The drawing package for the Wastewater Treatment System Upgrade at J.F. Shields High School for the Monroe County Board of Education shall be amended as follows:

The Contract and Specifications for the Wastewater Treatment System Upgrade at J.F. Shields High School for the Monroe County Board of Education shall be amended as follows:

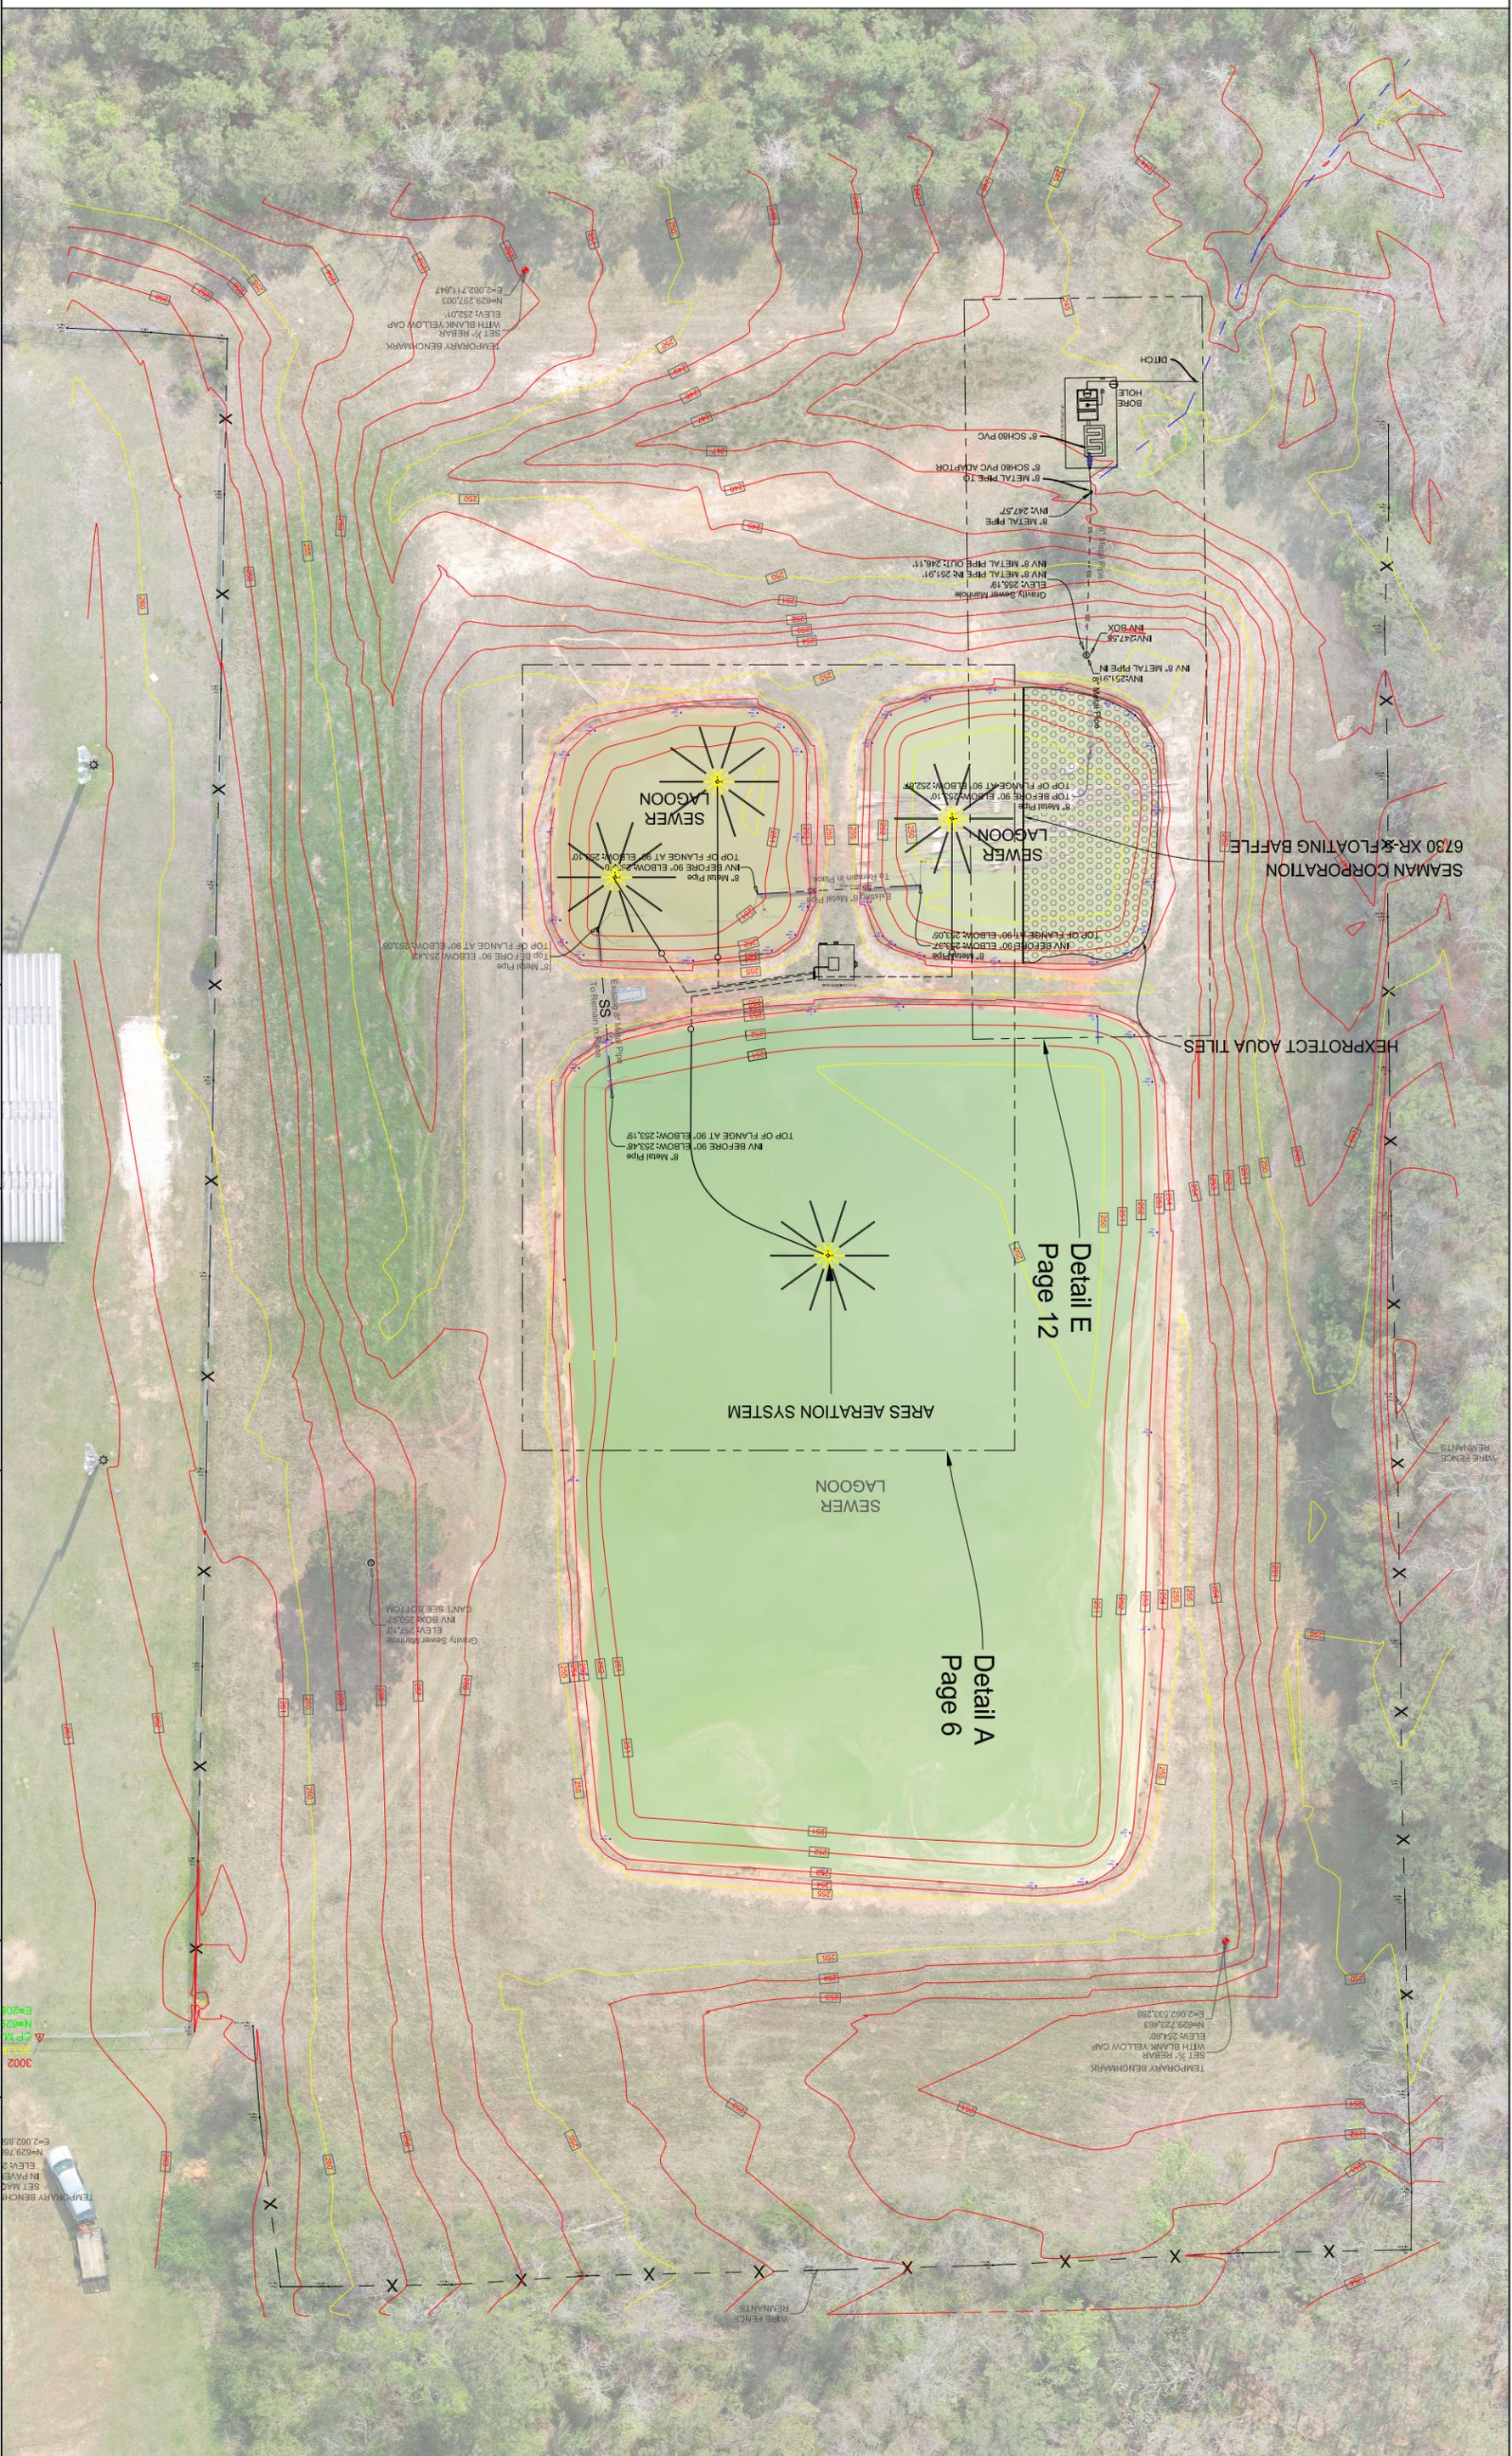
2. Sheet 4 – Proposed Site Plan shall be revised as follows:

The chlorine contact chamber and aeration tank shall be moved approximately 20 feet to the north due to undesirable site conditions in the proposed area. Please see attached revised drawing sheet.

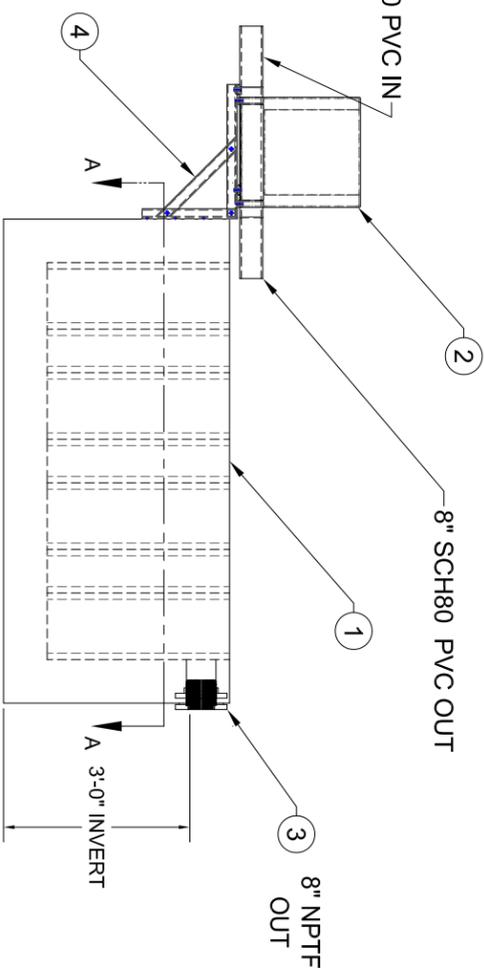
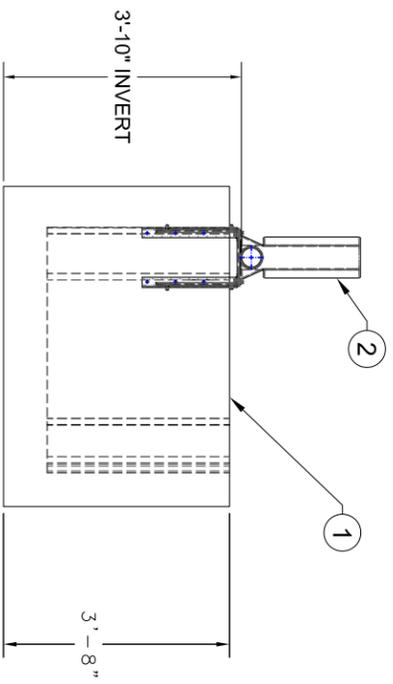
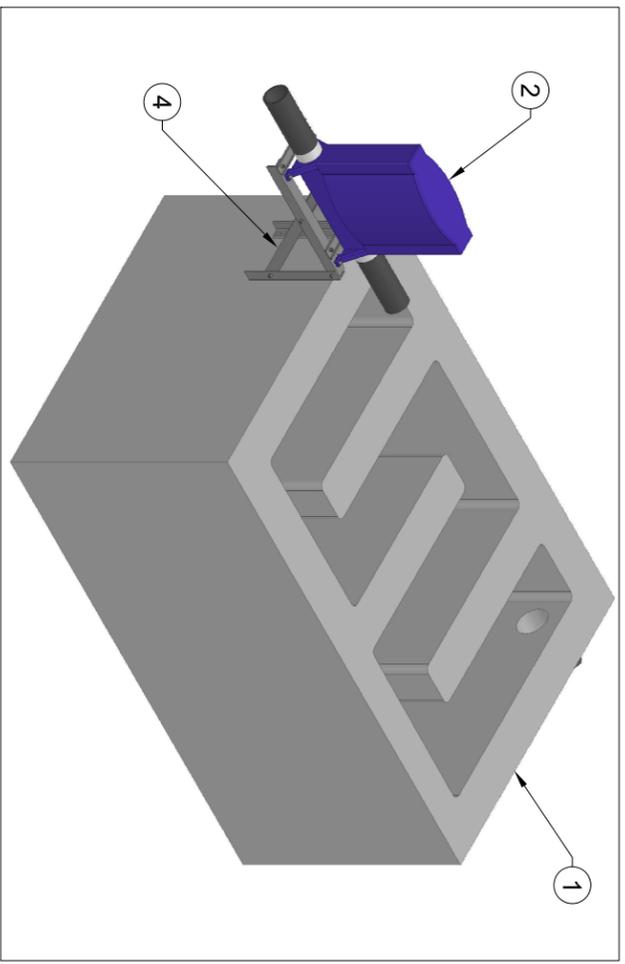
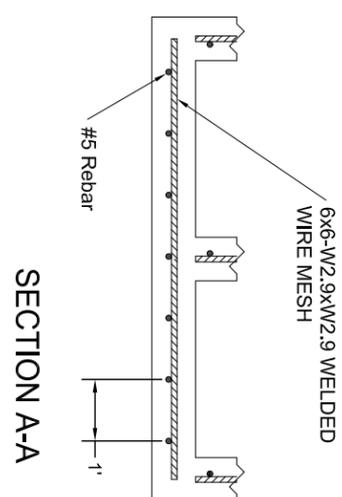
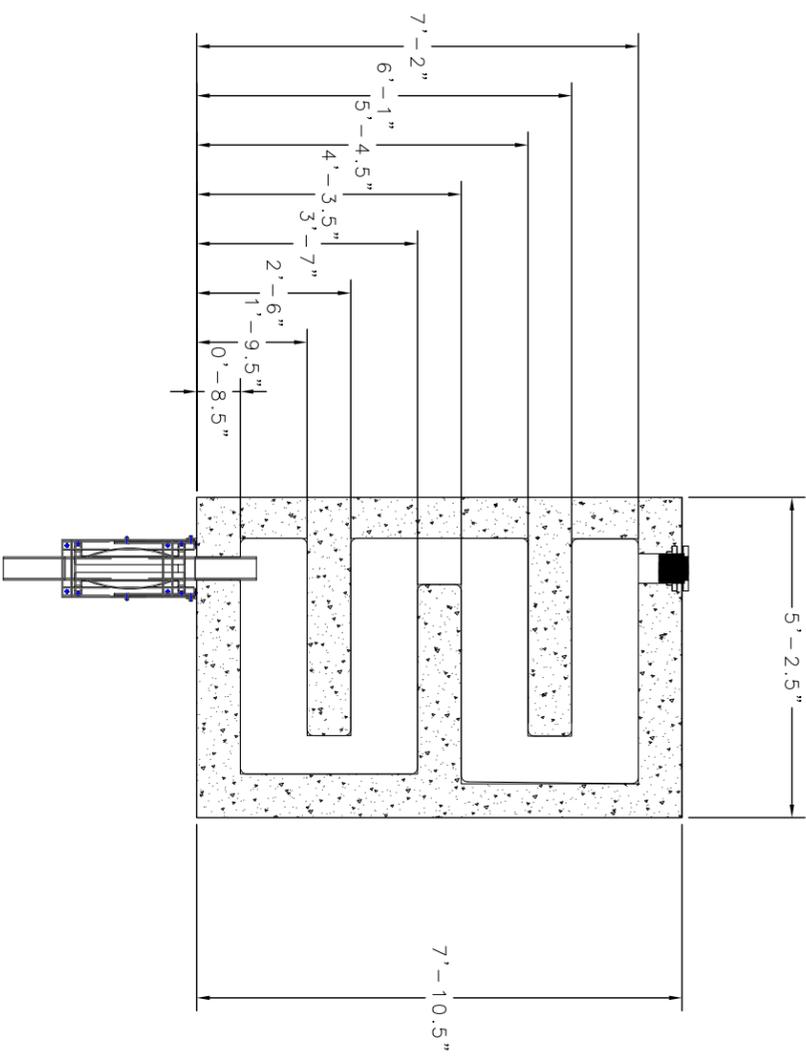
4. Sheet 17 - Disinfection System shall be revised as follows:

The molded inlets and outlet hubs for the Norweco Tablet Feed system shall be revised to 8-inches.
